Product Change Notification / NTDO-28XWRK640

CCB 4758 Initial Notice: Qualification of MPHL as a new final test site for selected ATSAMA5D2xx device family in 289L LFBGA (14x14x1.4mm) package.

CCB 4758
Pre and Post Comparison
PCN #: NTDO-28XWRK640

Cover Tape for T/R

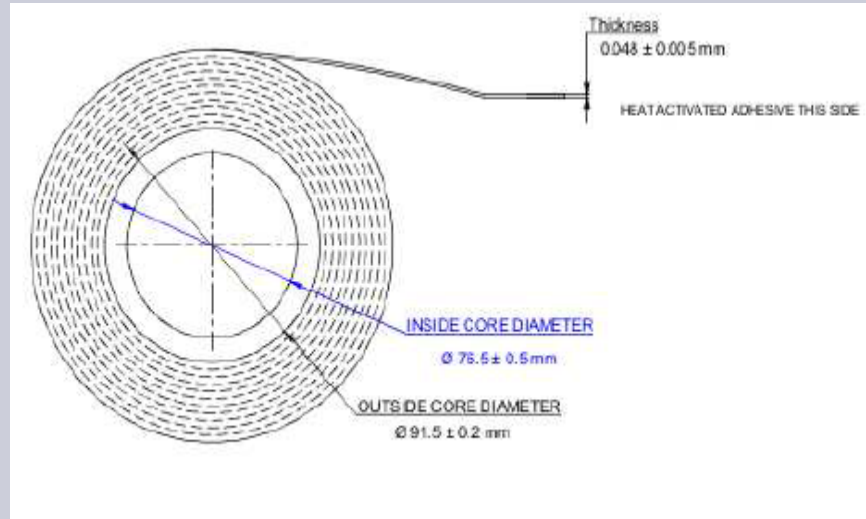
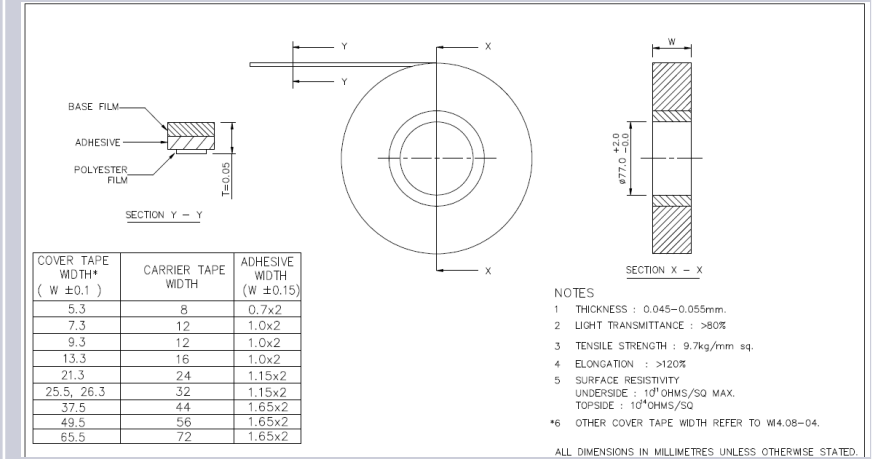
Carrier Width	Cover Tape Width (mm)	Thickness (mm)	Sealing Methodology
24	21	0.048	Hot Press

Carrier Width	Cover Tape Width (mm)	Thickness (mm)	Sealing Methodology
24	21.3	0.05 +/- 0.0005	Pressure Seal Activate

Plastic Reel for T/R

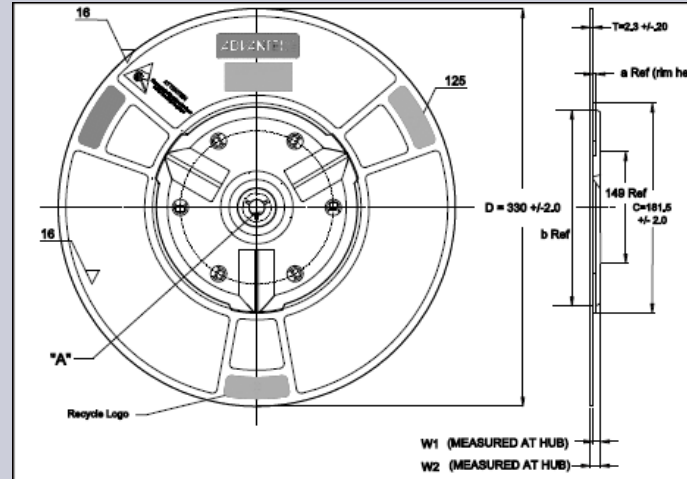
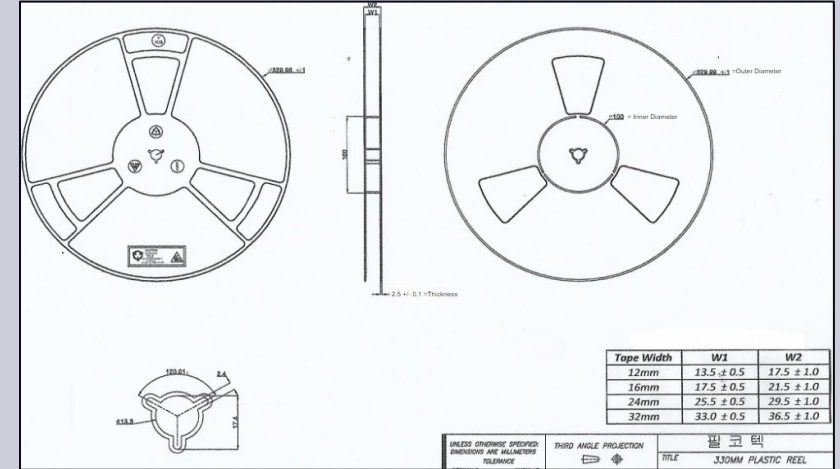
For Carrier Tape Width	Diameter	Hub	Color
24	330	181.5	White

For Carrier Tape Width	Diameter	Hub	Color
24	330	101.6	White
